environmental statement

CRYSTAL RIVER UNIT 3

FLORIDA POWER CORPORATION
DOCKET NO. 50-302

May 1973

FIGURE 2.5 TROPHIC PATHWAYS IN THE MARSHLAND ECOSYSTEM

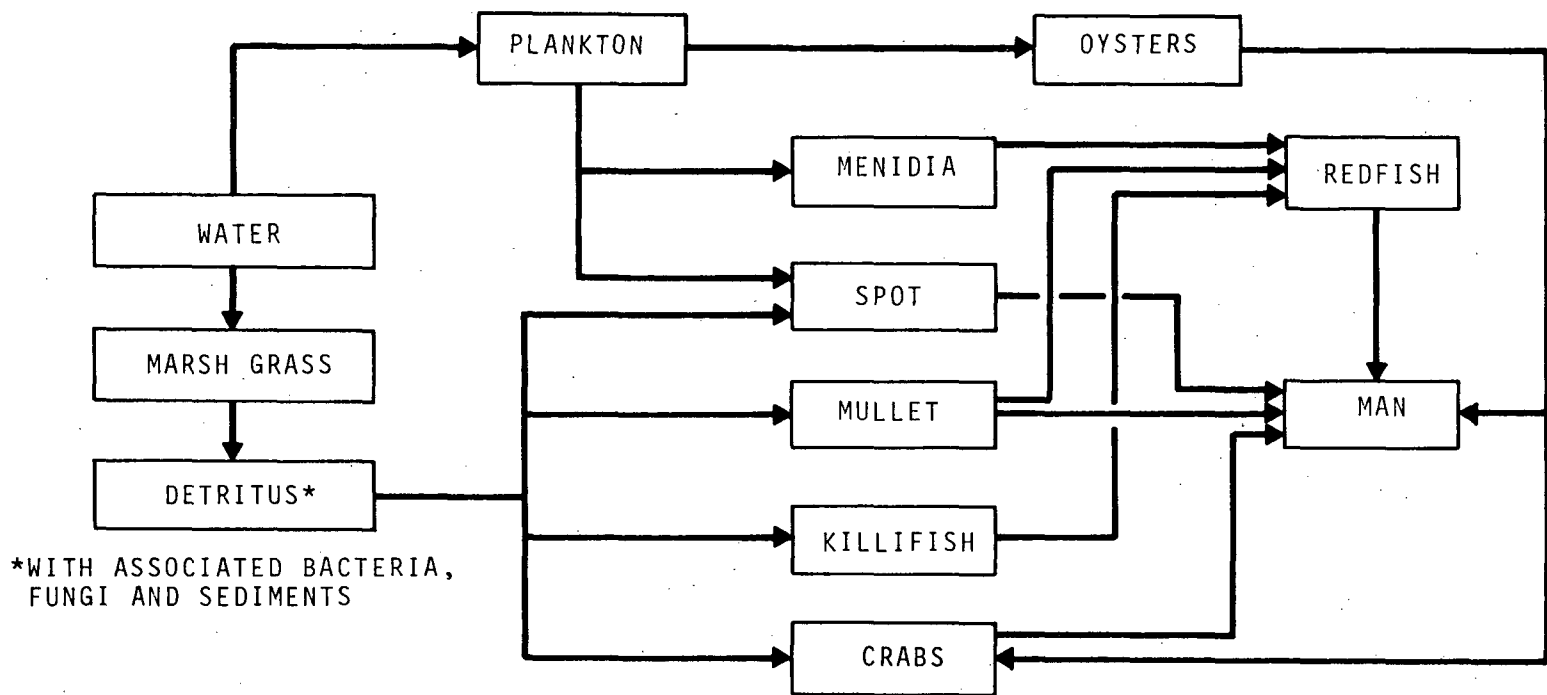
(4) Page 2-26. In Figure 2.5 the trophic pathways as presented are misleading; for example, oysters generally obtain their energy from filter feeding of detritus, rather than phytoplankton. Killifishes are thought to feed upon larval insects, primarily mosquito larvae, and Leiostomus xanthurus are not detritus feeders. Although many crabs are detritus feeders, those of importance to man, as Callinectes sapidus, are generally considered to be predators or scavengers. Table 2.6 has similar deficiencies. Inclusion of the category "bottom dwelling invertebrates," such as mollusks annelids and crustaceans, as the primary consumer organisms of detritus is suggested.
